REQUESTOR NAME: Clean Energy Association of B.C. (CEBC)

INFORMATION REQUEST ROUND NO: 2

BC HYDRO WANETA 2017 TRANSACTION

APPLICATION NAME: **Waneta 2017 Transaction Application (“Transaction” or “Application”)**

Figure 1 – Life Extension Scenario with Leading Utility Practice

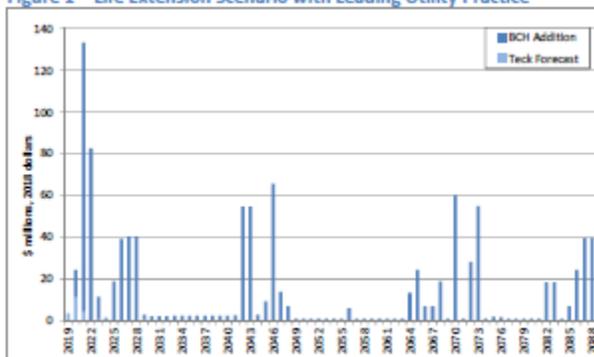
19.1 Since the total cost information as shown in these three charts does not appear to be confidential, please provide that data in the form of a working Excel model that can produce the charts. There is no need to provide the estimates of the sharing between BC Hydro and Teck (which Hydro wishes to keep confidential), only the totals as shown in the charts. A working Excel model with pasted values, rather than calculations, will be acceptable, but the model should be able to produce the three figures shown in Section 4.

Is any of the above three amounts included in the total capital estimates shown in Figures 1, 2, and 3 in the preamble to this question? If so, how much and in which years? If not, why not?

- 20.1 This response makes it very unclear as to what a "Harvesting Scenario" is intended to accomplish, compared to a "Life Extension Scenario". If the "Harvesting Scenarios" are expected to make the asset last in perpetuity, then doesn't that mean they are essentially the same as the "Life Extension Scenario"? Would they not, therefore, require the many of the same expenditures shown in Figure 1, rather than Figures 2 and 3?

Figure 2 – Harvest Scenario with Leading Utility Practice

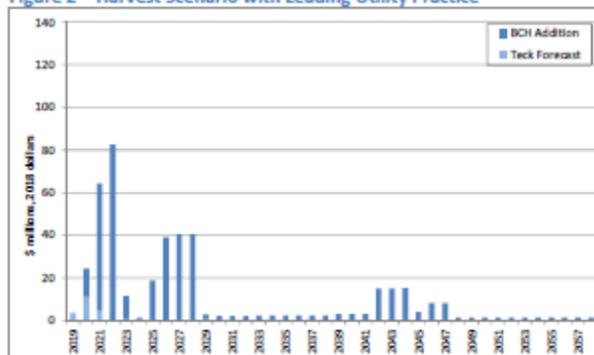
Figures 2 and 3 above, shown in the previous question, refer to a "Harvest Scenario", which covers only a 40 year time span. Yet, in its response to CEABC 1.8.6, BC Hydro states, "*BC Hydro expects the asset to operate in perpetuity, and has not prepared an estimate of the cost of decommissioning.*"

Figure 2 Monthly Average MW for Waneta Facilities

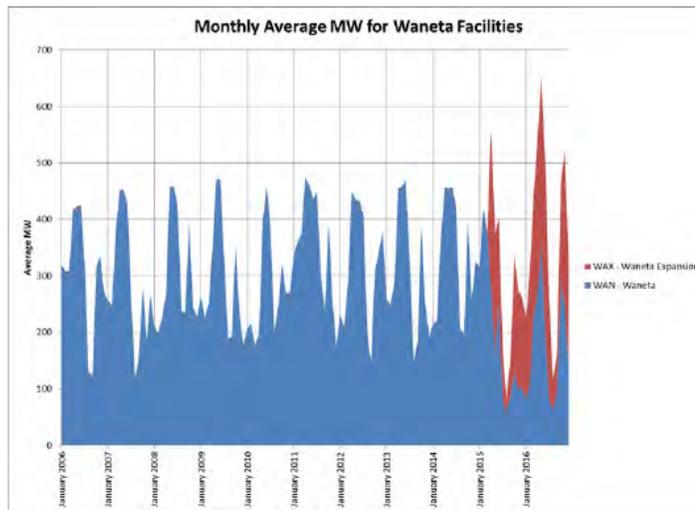
It is clear from this chart that the output from the facilities is highly variable from month to month. The Waneta plant itself is fluctuating 3:1 when comparing wet to dry months and the highest production months are always in the freshet season.

- 26.1 How are these wide fluctuations in output dealt with in terms of supplying the Teck smelter on an even and continuous basis?
- 26.2 How are these wide fluctuations dealt with in valuing the future market sales once BC Hydro acquires the additional 2/3 of the energy after the end of the Lease Period? Does the market price forecast include month to month variations in prices and a significant discount for the large amount of freshet energy that appears to be generated?

- 26.3 For purposes of this Waneta Transaction evaluation, has BC Hydro implemented a 3x12 time-of-delivery pricing table to deal with the fluctuating value of the Waneta generation in the same way it imposes on any independent power projects? If not, why not, and please implement such a table, in order to see its impact on the economic value of the project?
